ADDENDUM #3

ITB/RFP NUMBER: 2016017-PU-B

Park View Tank 0.5 MG Elevated Water Tank ITB

DATE: March 4, 2016

MASONRY ARCH. FAUX
FINISH EXAMPLE

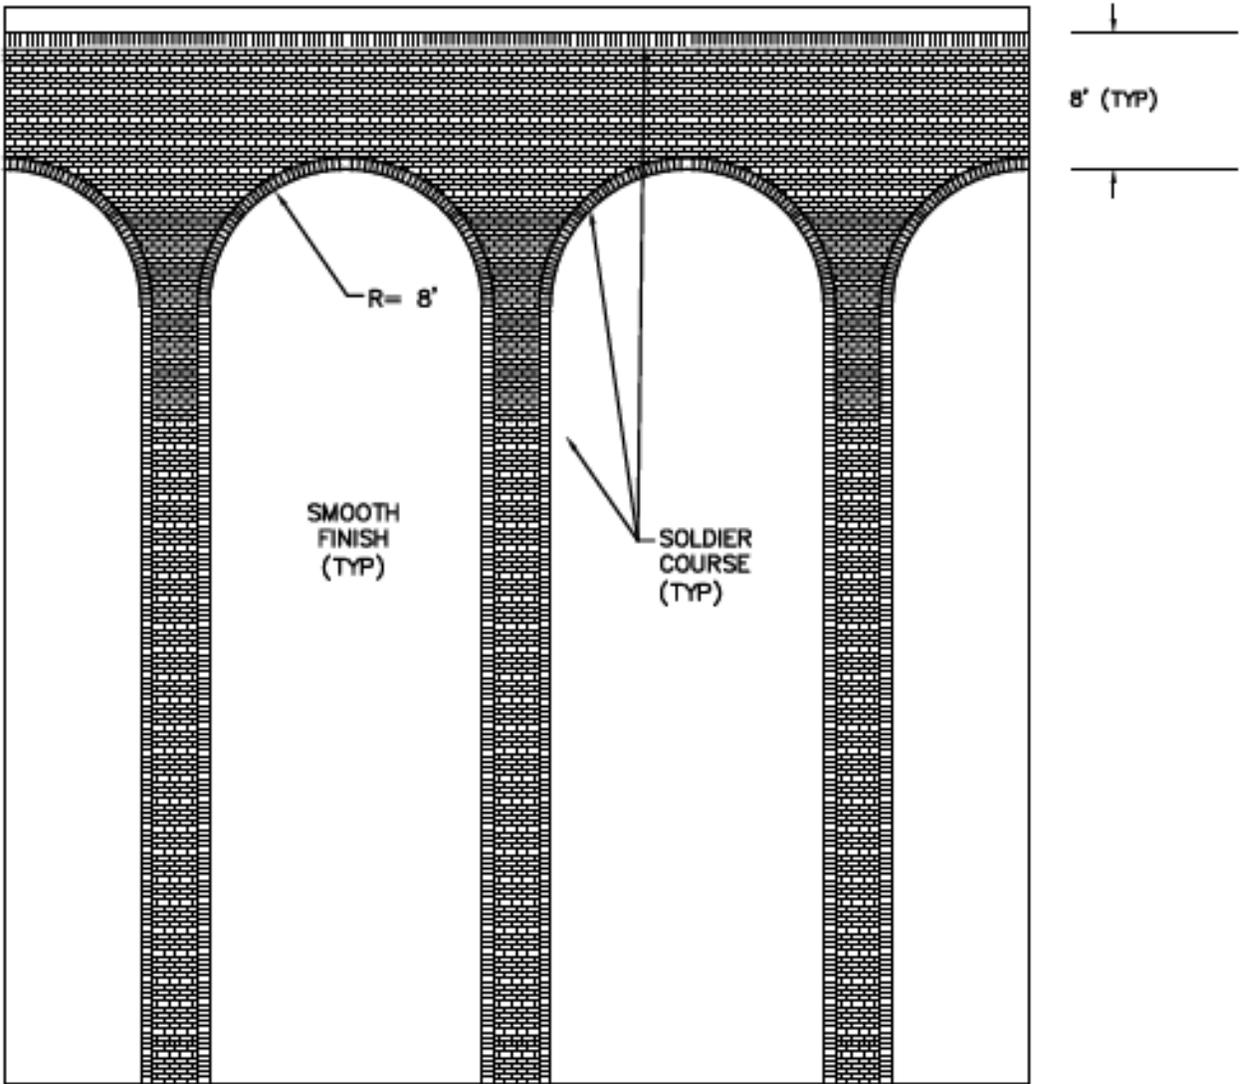
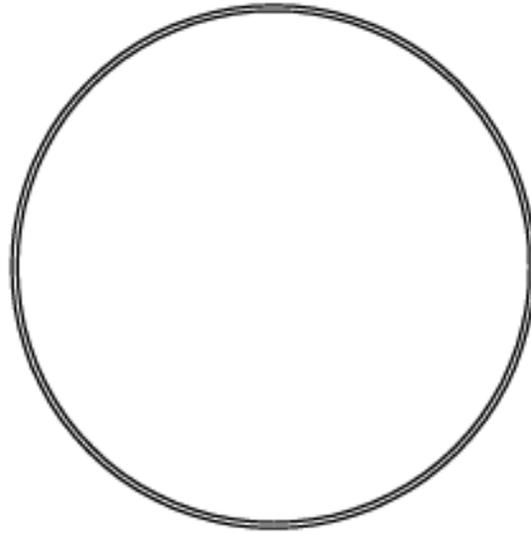
33. Question: Regarding Additive Alternate # 2 – please provide a photograph, sketch or a more in-depth description of the brick columns, smooth inlay and circular arch tops.

49. Question: We need drawings, details and item descriptions/photos of each Alt. Add for the concrete pedestal on the bid form. The information provided for the different concrete pedestal options is not adequate. Please clarify????

Answer: See attached figure for typical example. Note: Alternative finishes on the pedestal are no longer part of the bid; however, the low bidder may be required to furnish the cost and schedule impacts of architectural finish systems prior to award.

Answer: See attached example of brick arch finish; Ashlar Stone is a standard lay pattern for local stone masonry and is available in faux concrete stamping patterns; consult local masonry supplier/vendors for typical local pattern, this pattern is to encompass entire pedestal. Note: Alternative finishes on the pedestal are no longer part of the bid; however, the low bidder may be required to furnish the cost and schedule impacts of architectural finish systems prior to award.
